**SUBJECT: RECALL R09PW WHEELCHAIR LIFT POWER CABLE  
ROUTING**

# Wheelchair Lift Power Cable Routing

**MODELS AFFECTED:** 2010 BBCV Vision with Cummins Engine and Wheelchair Lift

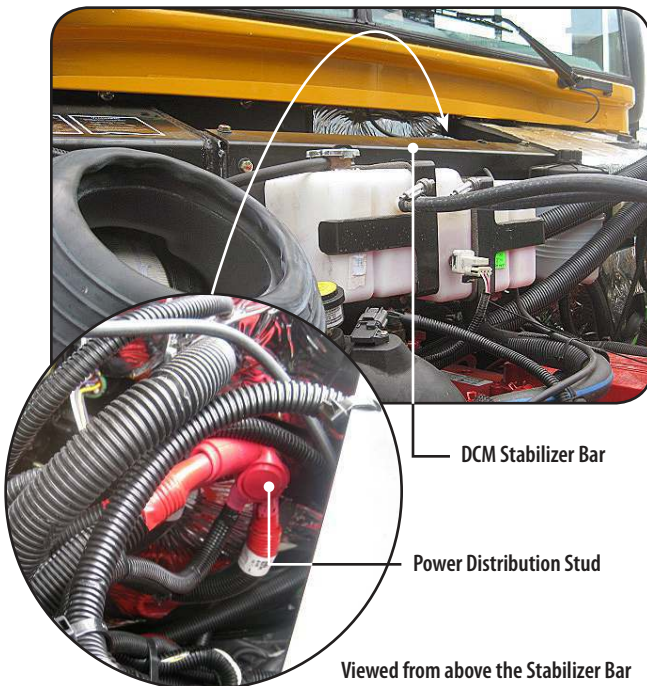
On affected buses, the wheelchair lift power cable may be routed too close to the engine exhaust manifold and/or turbocharger.

Locate the 12 volt insulated power distribution stud mounted on the firewall, left (roadside) of the rear of the engine. One of the cables connected to the stud pictured below is the power cable for the Wheelchair Lift. On its path toward the Wheelchair Lift, the cable crosses above the engine turbo charger and / or exhaust manifold on the right side (curbside) of the engine. Excess slack in this cable may allow it to droop and come in contact with the turbocharger or exhaust header.

This procedure describes inspection of the cable for damage, and routing of an undamaged cable to ensure necessary clearance. If the cable is found to be damaged, contact your Blue Bird Recall Administrator for further instructions.

**3** Inspect the Wheelchair Lift Power Cable for damage. Ensure that no part of the cable is within six inches of any surface of the turbocharger or the exhaust header.

**4** Secure the existing undamaged Wheelchair Power Cable against any possibility of contact with the turbocharger or exhaust header, as follows:

4.1 Remove all slack in the Wheelchair Lift Power Cable by carefully pulling the cable by hand.

4.2 Route the cable along the top of the other bundled cables which run parallel to it. Fasten the Wheelchair Lift Power Cable to the Main Wire Harness Bundle, using a 1/4" cable tie (00029999), so as to hold the cable slack above the point of attachment.

4.3 Coil the resulting slack and wrap it with a 1/4" (00029999) cable tie.

4.4 Fasten the coiled cable to a hole in the Driver Control Module Stabilization Bar, using a 1/2" cable tie (00029998). Ensure that the bundle of cables is secured a minimum of six inches from the engine surface.
